**National Committee on
Seismic Design Parameters (NCSDP)
for River Valley Projects**

**MINUTES
OF
25th MEETING
(28th June & 8th July, 2013)**

**MINUTES OF THE 25TH MEETING OF NATIONAL COMMITTEE ON SEISMIC DESIGN
PARAMETERS (NCSDP) FOR RIVER VALLEY PROJECTS HELD ON 28TH JUNE AND 8TH
JULY, 2013 IN CWC, NEW DELHI**

25.2.2. Rupsiabagar Khasiabara H.E. Project, Uttarakhand

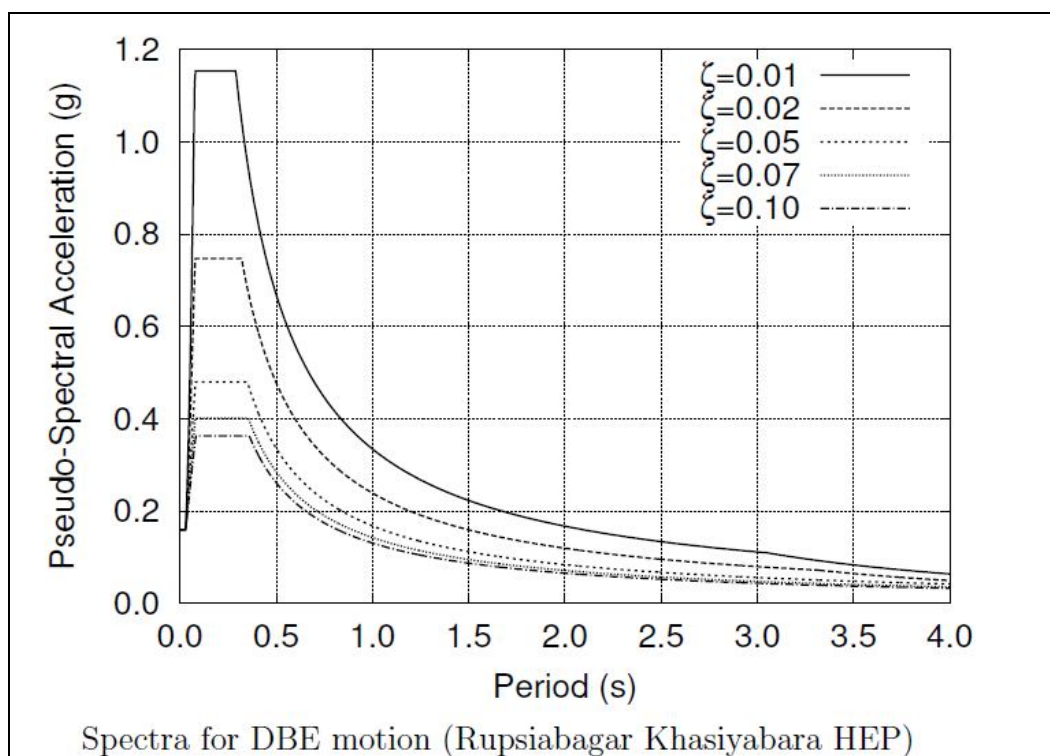
A presentation on the study report was made by the project authorities. **The Committee in light of its earlier deliberation (General), approved the study report of Rupsiabagar Khasiabara H.E. Project, Uttarakhand incorporating the revised seismic design parameters as summarized below:**

Max. Credible Earthquake Magnitude	8	Distance to Zone of Energy Release (km)	15	Focal depth (km)	15
Horizontal seismic co-efficient (α_h)	0.13	Vertical seismic co-efficient (α_v)	0.09		
Strong motion duration (sec)	12 sec				
Report reference	IIT Roorkee's Report No. EQD-3016/2007-08 (April-2008) along with letter dated 29.07.2013 indicating revised parameters.

23.3.1 Rongnichu HE Project, Sikkim

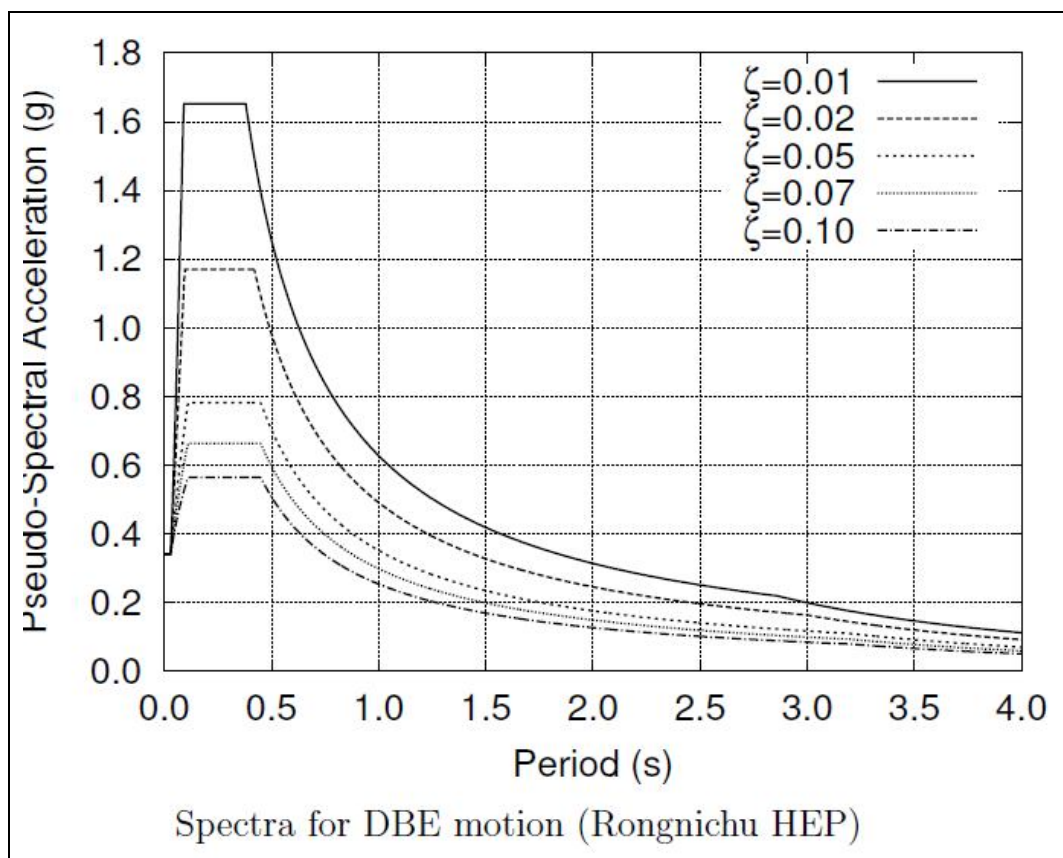
A presentation on the study report was made by the project authorities. **The Committee in light of its earlier deliberation (General), approved the study report of Rongnichu HE Project, Sikkim incorporating the revised seismic design parameters as summarized below:**

Max. Credible Earthquake Magnitude	8.0	Epicentral distance (km)	4	Focal depth (km)	15
Horizontal seismic co-efficient (α_h)		0.21		Vertical seismic co-efficient (α_v)	0.14
Report reference		IIT Roorkee Report No. EQ: 2012-32 [(Project No. EQD-6005/2012-2013(October-2012)] along with letter dated 29.07.2013 indicating revised parameters.

25.3.2 Gongri HE Project, Arunachal Pradesh

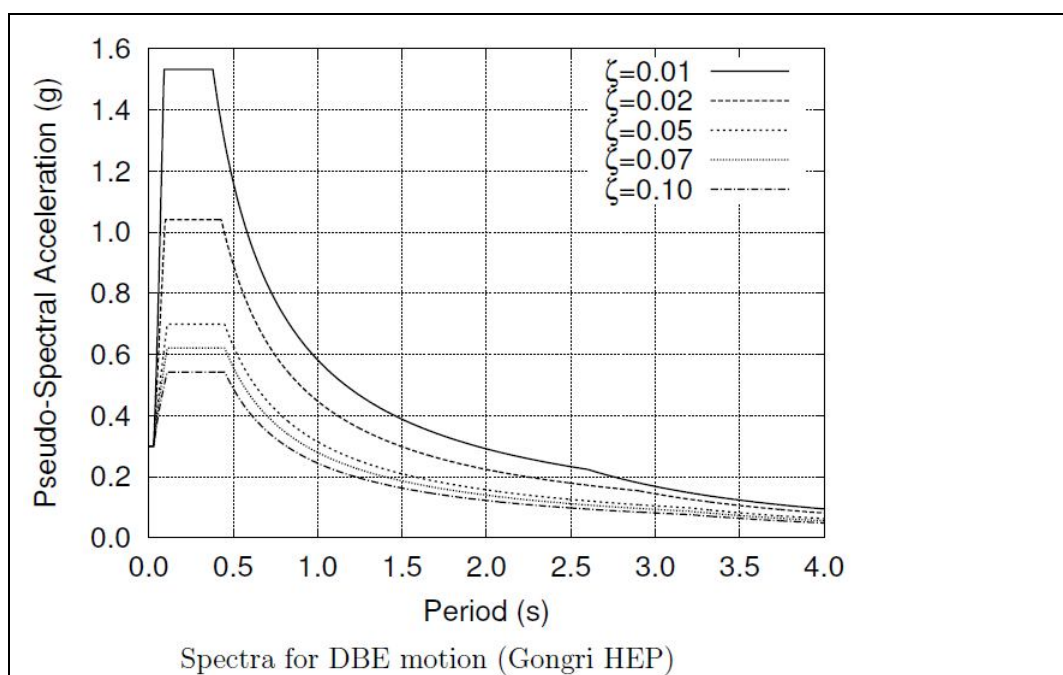
A presentation on the study report was made by the project authorities. **The Committee in light of its earlier deliberation (General), approved the study report of Gongri HE Project, Arunachal Pradesh incorporating the revised seismic design parameters as summarized below:**

Max. Credible Earthquake Magnitude	8.0	Epicentral distance (km)	5	Focal depth (km)	15
Horizontal seismic co-efficient (α_h)		0.19	Vertical seismic co-efficient (α_v)		0.13
Report reference	IIT Roorkee Report No. EQ: 2012-24 [(Project No. EQD-3016/2011-2012 (September-2012)] along with letter dated 29.07.2013 indicating revised parameters.

25.3.3 Ratle HE Project, Jammu & Kashmir

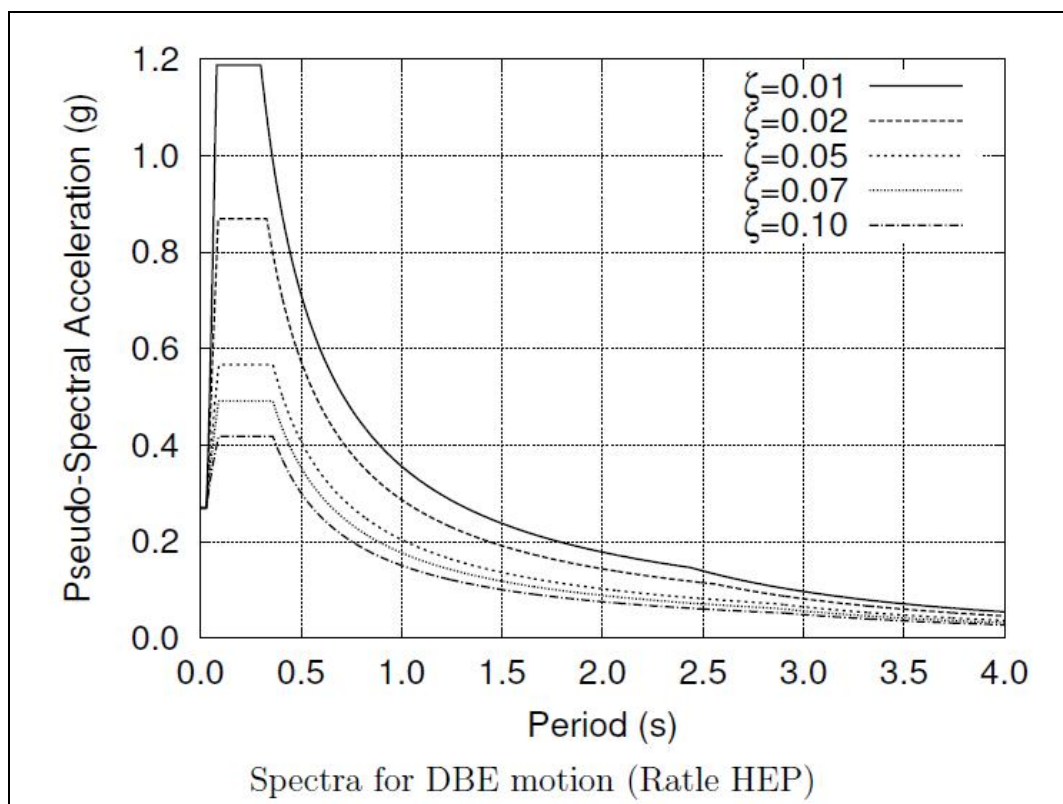
A presentation on the study report was made by the project authorities. The project authorities have informed that MEQ studies for 133m high concrete dam have been planned in association with IIT Roorkee, and final study report will be submitted latest by July, 2014.

The Committee in light of its earlier deliberation (General) and subject to fulfillment of the commitment agreed by the project authority, approved the study report of Ratle HE Project, Jammu & Kashmir incorporating the revised seismic design parameters as summarized below:

Max. Credible Earthquake Magnitude	7.5	Epicentral distance (km)	5	Focal depth (km)	15
Horizontal seismic co-efficient (α_h)		0.15	Vertical seismic co-efficient (α_v)		0.10
Strong motion duration (sec)		8			
Report reference	IIT Roorkee Report [Project No. EQD-6008/12-13 (January -2013)] along with letter dated 29.07.2013 indicating revised parameters.

25.3.4 Rangit-II H.E. Project, Sikkim

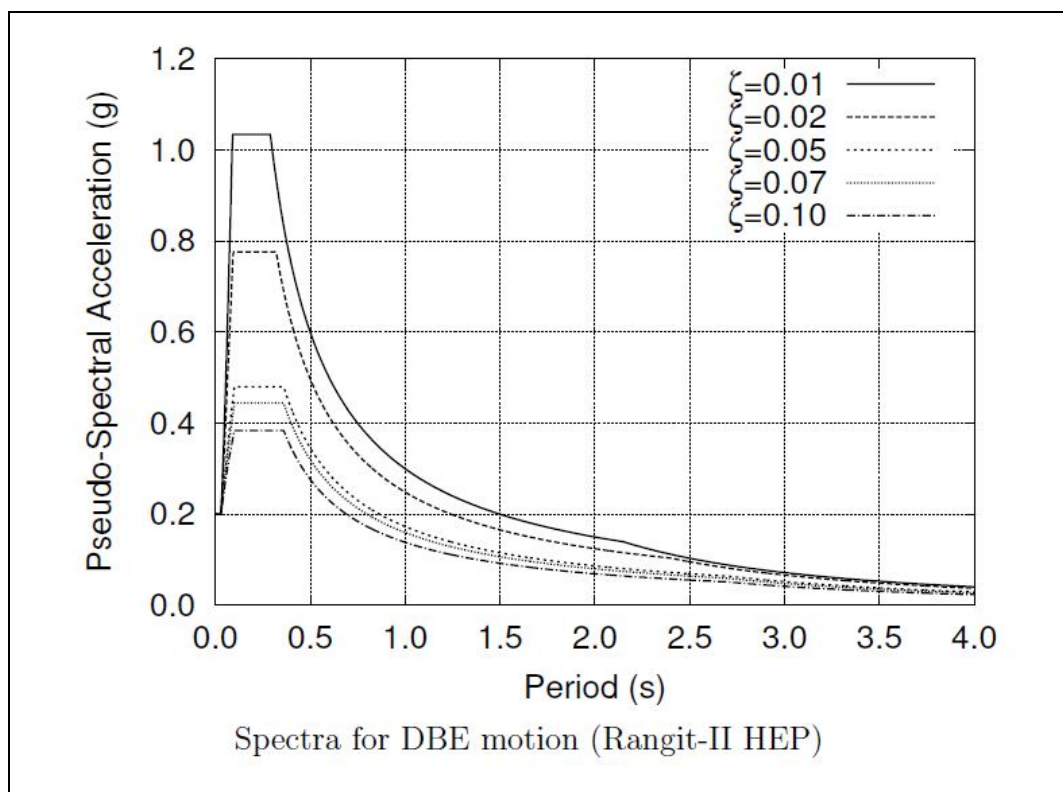
A presentation on the study report was made by the project authorities. **The Committee in light of its earlier deliberation (General), approved the study report of Rangit-II H.E. Project, Sikkim incorporating the revised seismic design parameters as summarized below:**

Max. Credible Earthquake Magnitude	7.5	Epicentral distance (km)	5	Focal depth (km)	15
Horizontal seismic co-efficient (α_h)		0.13	Vertical seismic co-efficient (α_v)		0.09
Report reference:	IIT Roorkee Report No. EQ: 2012-10 [(Project No. EQD-3011/11-12 (April-2012))] along with letter dated 29.07.2013 indicating revised parameters.

25.3.5 Thana Plaun HEP, Himachal Pradesh

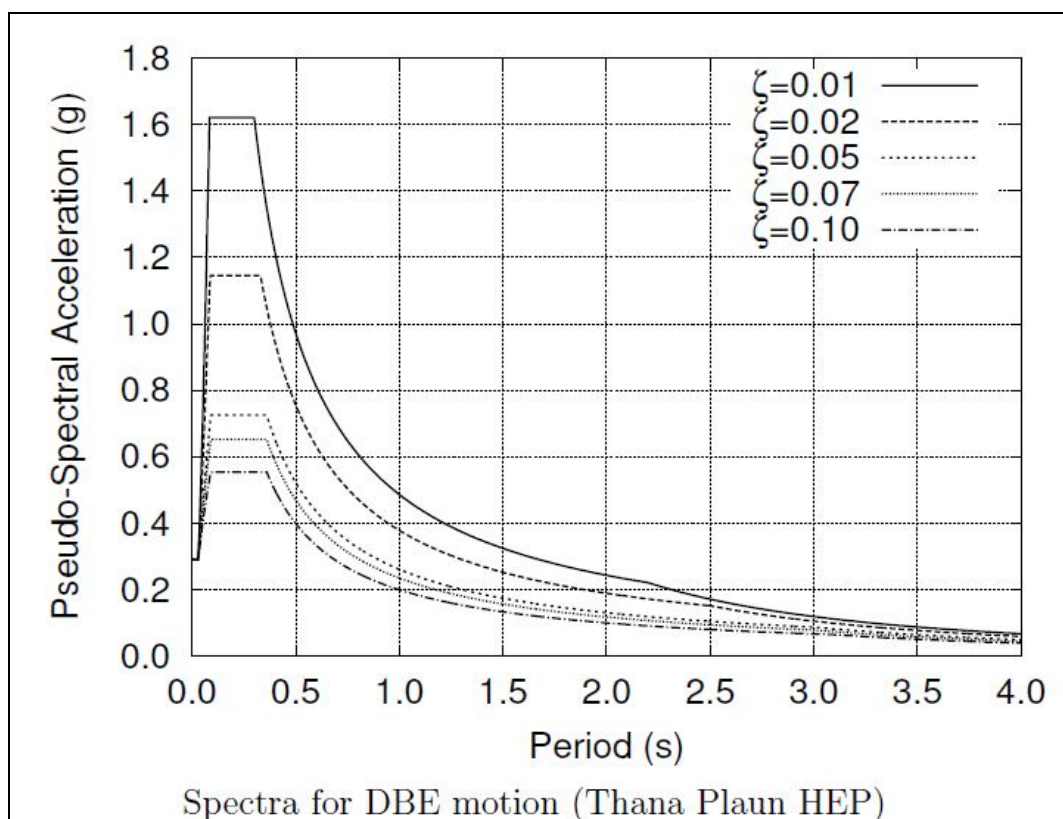
A presentation on the study report was made by the project authorities. The project authorities have informed that the MEQ studies for 106.7 m high concrete dam will be taken up in association with IIT Roorkee and final study report will be submitted latest by July, 2014.

The Committee in light of its earlier deliberation (General) and subject to fulfillment of the commitment agreed by the project authority, approved the study report of Thana Plaun HEP, Himachal Pradesh incorporating the revised seismic design parameters as summarized below:

Max. Credible Earthquake Magnitude	7.0	Epicentral distance (km)	5	Focal depth (km)	15
Horizontal seismic co-efficient (α_h)		0.19	Vertical seismic co-efficient (α_v)		0.13
Report reference	IIT Roorkee Report No. EQ: 2012-23 [(Project No. EQD-3013/2010-2011, (August, 2012)] along with letter dated 29.07.2013 indicating revised parameters

25.3.6 Shongtong-Karcham HEP, Himachal Pradesh

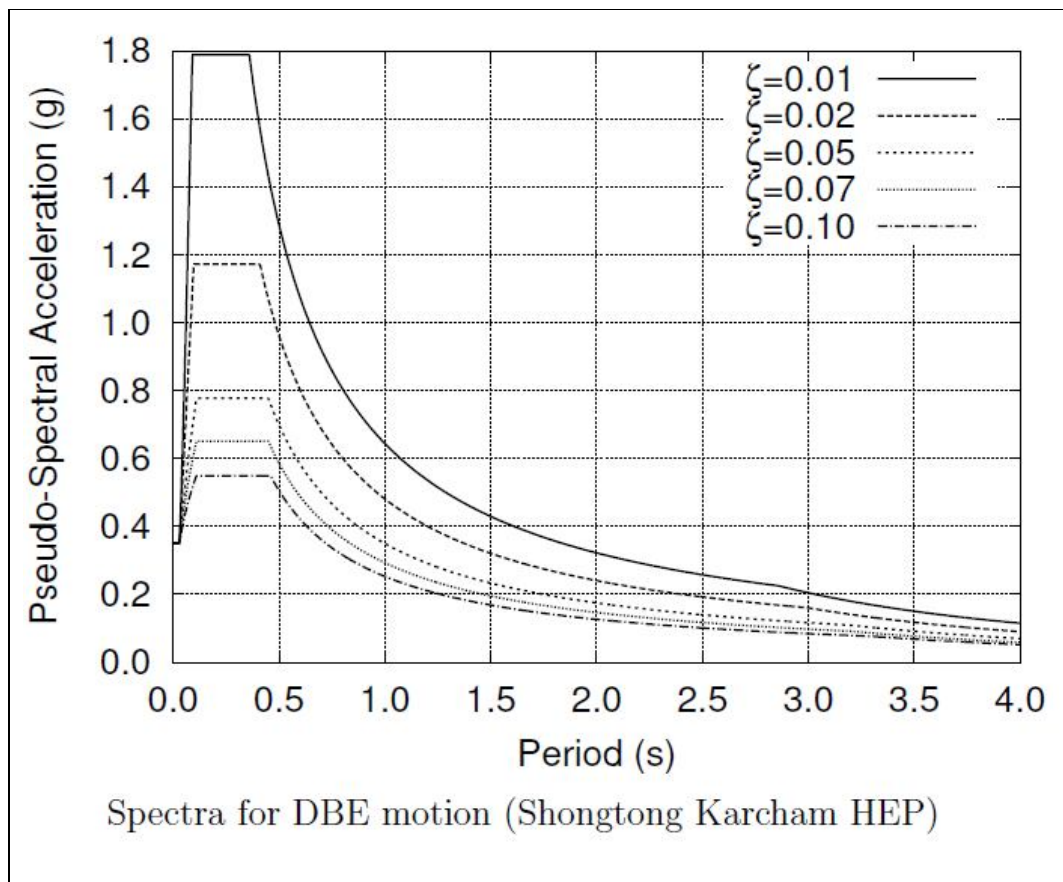
A presentation on the study report was made by the project authorities. **The Committee in light of its earlier deliberation (General), approved the study report of Shongtong-Karcham HEP, Himachal Pradesh incorporating the revised seismic design parameters as summarized below:**

Max. Credible Earthquake Magnitude	8.0	Epicentral distance (km)	3	Focal depth (km)	15
Horizontal seismic co-efficient (α_h)		0.21	Vertical seismic co-efficient (α_v)		0.14
Strong motion duration (sec)		19			
Report reference	IIT Roorkee Report No. EQ: 2013-07 [(Project No. EQD-6027/2012-2013, (April, 2013))] along with letter dated 29.07.2013 indicating revised parameters.

25.3.7 Miyar HEP, Himachal Pradesh

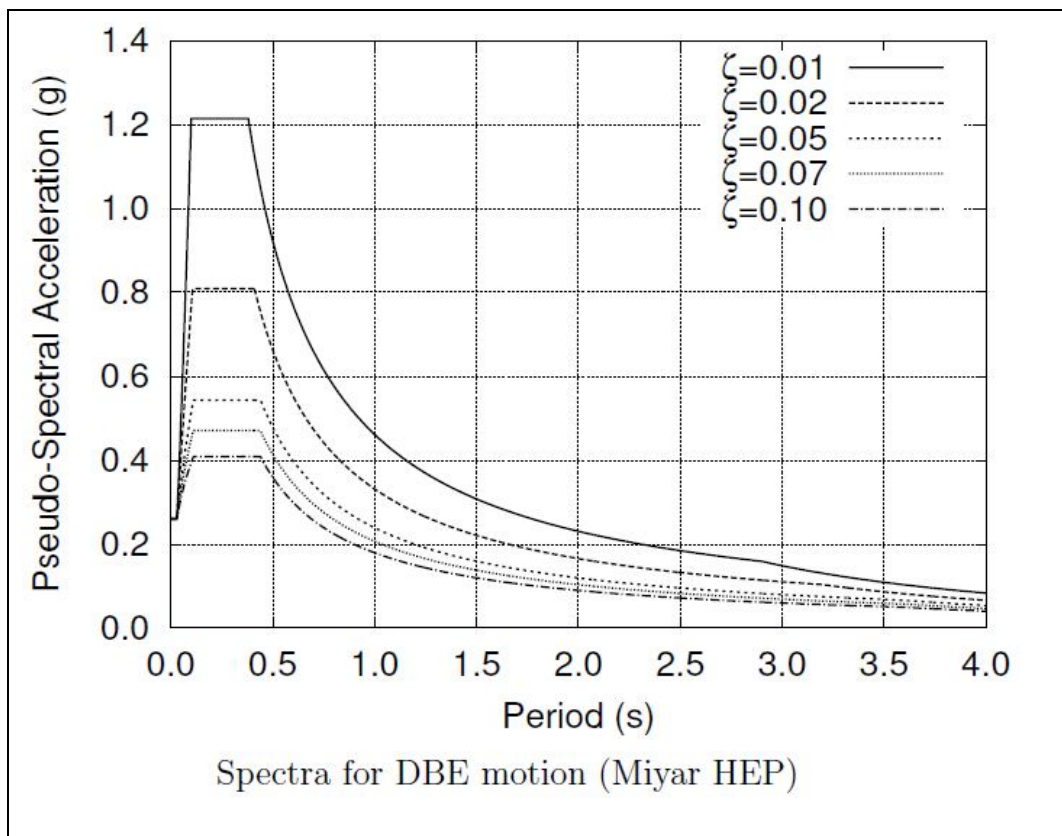
A presentation on the study report was made by the project authorities. **The Committee in light of its earlier deliberation (General), approved the study report of Miyar HEP, Himachal Pradesh incorporating the revised seismic design parameters as summarized below:**

Max. Credible Earthquake Magnitude	8.0	Epicentral distance (km)	8	Focal depth (km)	15
Horizontal seismic co-efficient (α_h)		0.14	Vertical seismic co-efficient (α_v)		0.10
Strong motion duration (sec)		16			
Report reference	IIT Roorkee Report No. EQ: 2013-09 [(Project No. EQD-6009/2012-2013, (May, 2013)] along with letter dated 29.07.2013 indicating the revised parameters.

25.3.8 Nyukcharong Chu HEP, Arunachal Pradesh

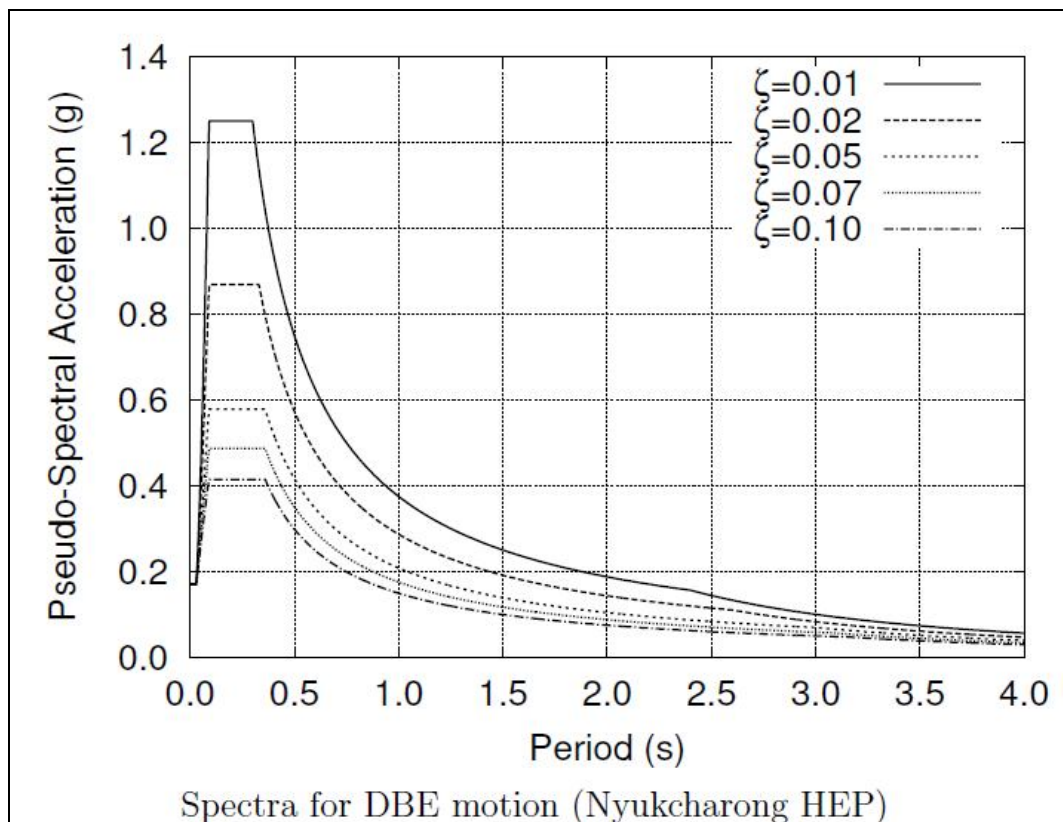
A presentation on the study report was made by the project authorities. **The Committee in light of its earlier deliberation (General), approved the study report of Nyukcharong Chu HEP, Arunachal Pradesh incorporating the revised seismic design parameters as summarized below:**

Max. Credible Earthquake Magnitude	8.0	Epicentral distance (km)	5	Focal depth (km)	15
Horizontal seismic co-efficient (α_h)		0.15	Vertical seismic co-efficient (α_v)		0.10
Report reference	IIT Roorkee Report No. EQ: 2011-29 [(Project No. EQD-3002/10-11 & 3007/11-12; August 2011)] along with letter dated 29.07.2013 indication the revised parameters.

ESTIMATION OF SITE-SPECIFIC DESIGN SEISMIC GROUND MOTION FOR HALON PROJECT, MADHYA PRADESH

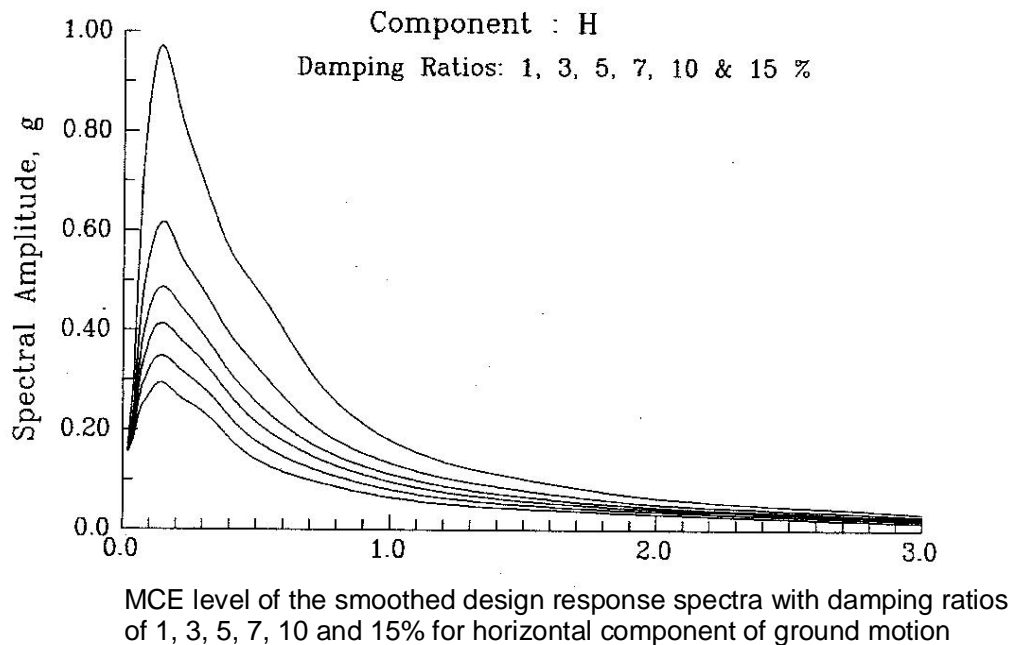
Technical Report No.4555 provides the MCE level of design spectra for damping ratios 1,3,5,7,10,15% for horizontal and vertical ground motions. In the report it is recommended that the DBE level of design spectra be taken as one half of the MCE level of spectra. The horizontal seismic coefficient is taken as 1/3.75 of the spectral acceleration at the period 0.2 sec of the DBE level design spectrum with damping ratio of 10% for earthen dam and 5% for concrete/masonry dams.

For the earthen dam portion of the Halon dam, using the 10% damped horizontal design spectrum the horizontal seismic coefficient (α_h) works out to be 0.04 and the vertical seismic coefficient (α_v) taken as 2/3rds of α_h is found to be 0.03. Similarly, for the concrete spillway section, using the 5% damped horizontal design spectrum the horizontal seismic coefficient (α_h) works out to be 0.06 and the vertical seismic coefficient (α_v) taken as 2/3rds of α_h is found to be 0.04. The design spectra for horizontal component of ground motion are plotted below.
